**Village of Oxford Planning Commission Agenda**  
**Council Chamber- 22 W. Burdick St., Oxford MI, 48371**  
**Tuesday, July 20, 2021, 7:00 P.M.**

Subject: **Davis New Building B – Site Plan Review #1** (*Site Plan Dated June 9, 2021*)

RE: Engineering Site Plan Review for 592 Lakeville Road, Oxford, MI

ONE DROP BREWERY  
PERGOLA PROPOSAL  
130 OAKDELL STREET  
OXFORD, MI 48371

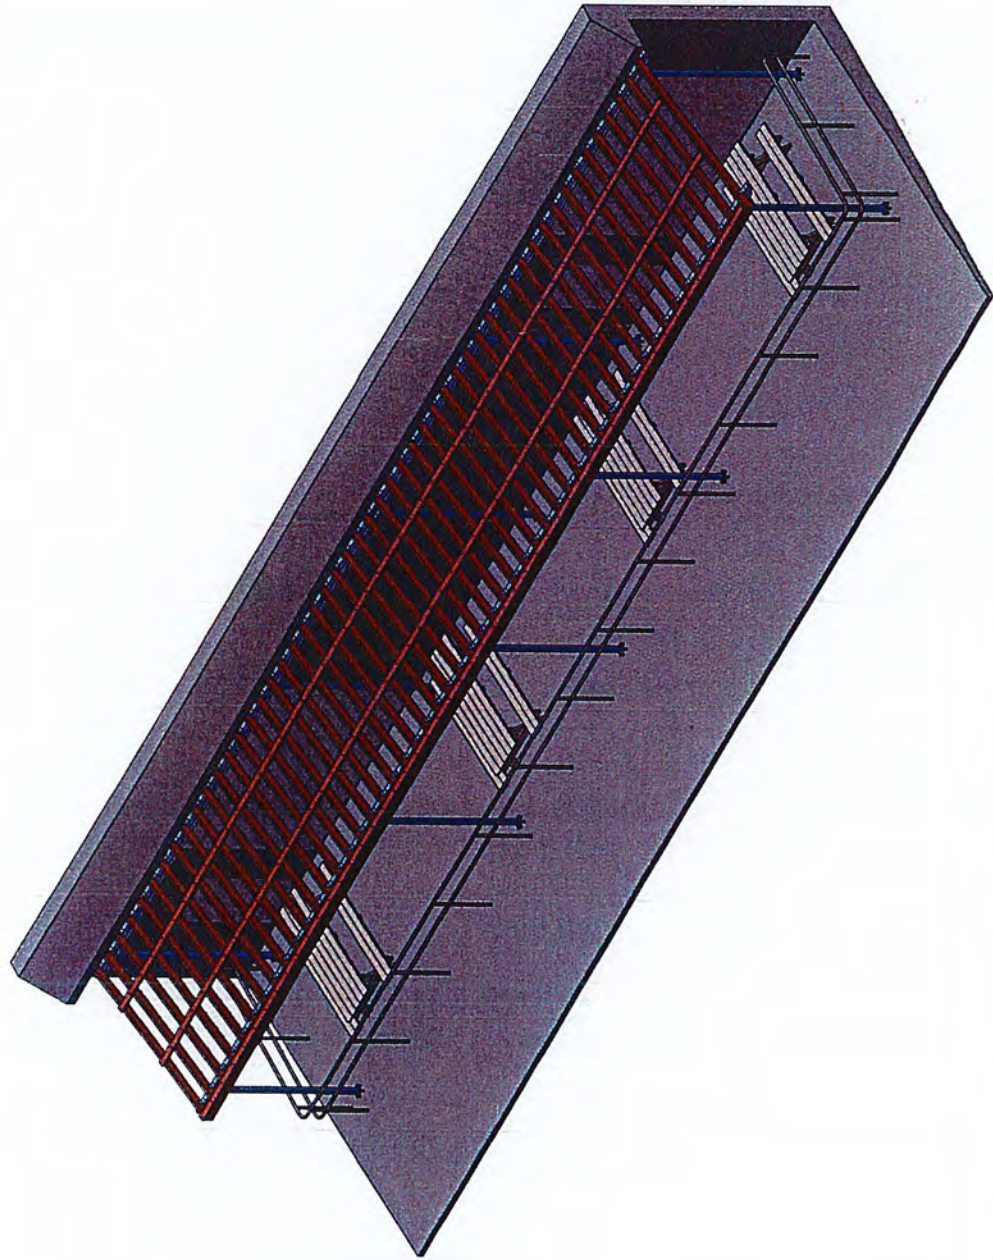
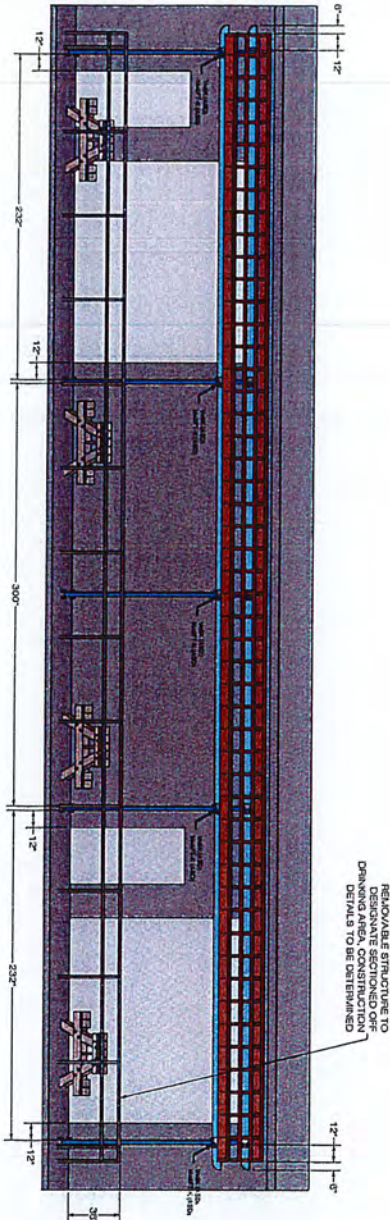
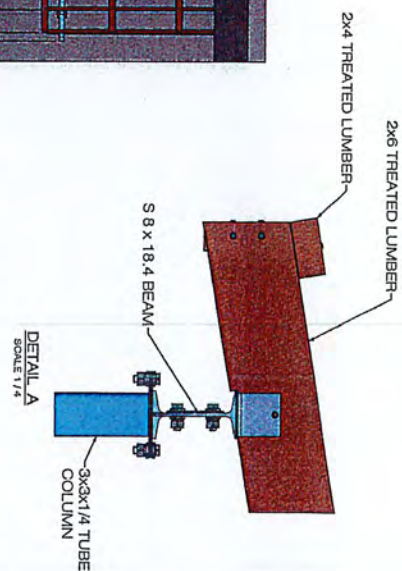
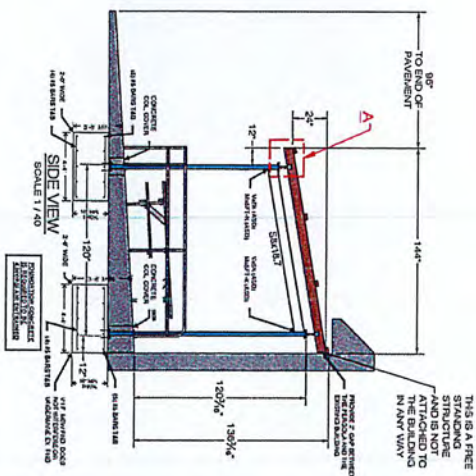
The applicant is proposing to use posts with ropes between the posts to provide a physical delineation. The Planning Commission has required all other outdoor seating operators to provide a metal or wood railing system consistent with ordinance standards. The applicant must provide a metal or wood railing system consistent with ordinance standards.

The applicant has already constructed a pergola over the proposed outdoor seating area. Photos available on Google Maps also show the outdoor area roped off the entire width of the existing drive aisle and being used as a gaming space. The installation of the pergola has reduced the drive aisle width along the building from 20 feet to eight feet according to the side view on Sheet 3 of the pergola overall layout. Section 7.1.12 requires a two-way maneuvering aisle to be 20 feet wide and a one-way maneuvering aisle to be 12 feet wide. In addition, a one-way maneuvering aisle requires a means of access at the end of the one-way aisle. As a result, access to the four parking spaces and dumpster enclosure located to the north of the pergola is no longer in

compliance with the zoning ordinance and must be removed. Any special use approval granted must be contingent upon the applicant removing the parking space striping, relocating the dumpster enclosure to a location accessible by a trash vehicle and reducing the maximum allowed capacity on the site. (See paragraph 8 below.) The applicant must submit a revised site plan showing the required changes.

- A. The installation of a metal or wood railing system consistent with ordinance standards.
- B. Providing the style and materials information of the proposed picnic tables and railing system.
- C. The outdoor dining area not operating after 11 p.m. and not before 7 a.m.
- D. The installation of a "No food or beverages allowed beyond this point" sign prior to operation.
- E. The submittal of an amended site plan that includes the following:
  - 1. The removal of the parking space striping north of the building.
  - 2. The relocation of the dumpster enclosure to a location accessible by a trash vehicle.
  - 3. The location of the pergola and outdoor seating area on the site.
  - 4. A note stating the maximum customer occupancy shall be 36 customers and corresponding signage installed within the bar/lounge area.
